MONTICELLO NUCLEAR GENERATING PLANT
Docket No. 50-263 License No. DPR-22

Additional Information Pertaining to the
Second 10-Year Interval Inservice Inspection Program

Second Ten Year Interval Inservice
Inspection Program Response to
Request for Additional Information

Figure 1
Qualification Program Results:
ASME V vs NSP Procedure

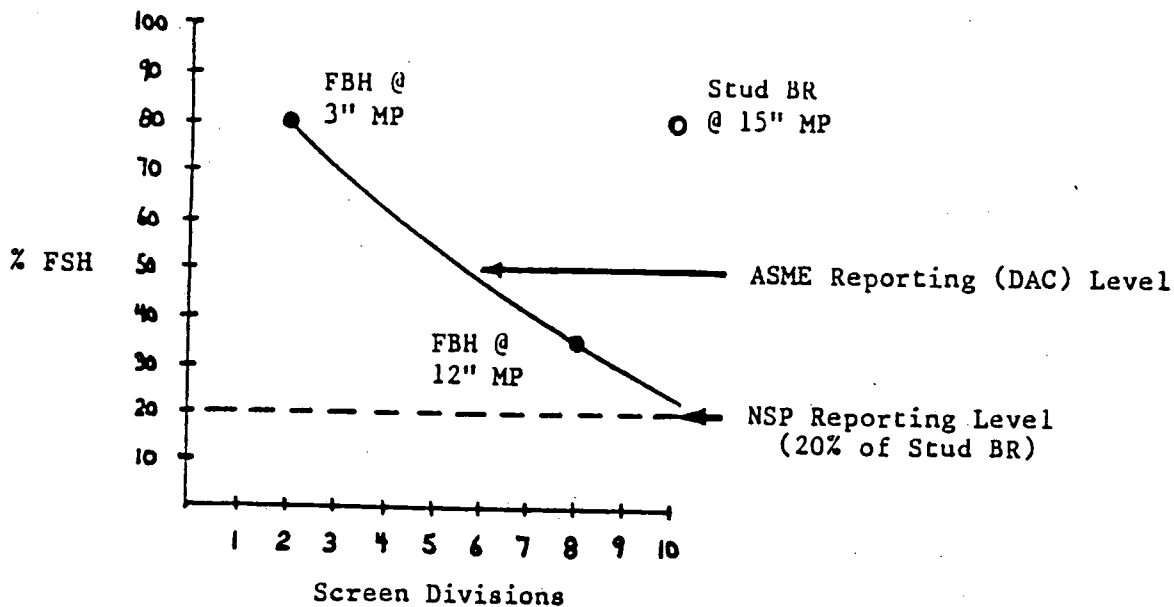
Relief Request 24 requests relief from performing ultrasonic examinations of Recirculation pump flange bolts and Recirculation valve bonnet bolting in accordance with the Code requirements. Provide the procedure used for calibrating and performing ultrasonic examinations of the subject bolting. In order for the propose alternative examination to be acceptable, the Licensee should be using Code Case N-375-2 or the latest Code Edition and Addenda for examination of the subject bolting.

Code Case N-375-2 was not effective until April 5, 1984 and does not apply to Monticello's ISI program that was initially submitted in December 1981. The alternative examination falls under IWA-2240 to the extent that the procedure has been successfully demonstrated to the Inspector (Authorized Nuclear Inservice Inspector) as defined by Section XI.

A qualification program was initiated in response to similar questions concerning this item in our original Prairie Island Inservice Inspection submittal. During the qualification test it was demonstrated that the NSP-UT-4 procedure, which utilizes a back reflection technique for flaw evaluation, was a more sensitive examination than the technique specified in ASME Section V, Article 5, Paragraph T-252.2. The results indicated that at the same

nominal metal path, the NSP procedure was approximately 6db more sensitive than the ASME technique (See Figure 1). In addition to the percent-of-DAC reporting level, the NSP procedure dictates that any reflector, regardless of amplitude, which is accompanied by a 50% loss of back wall reflection must be reported/evaluated. As poorer end reflecting surfaces are encountered, the NSP procedure tends to become a much more conservative approach to bolt and stud examination.
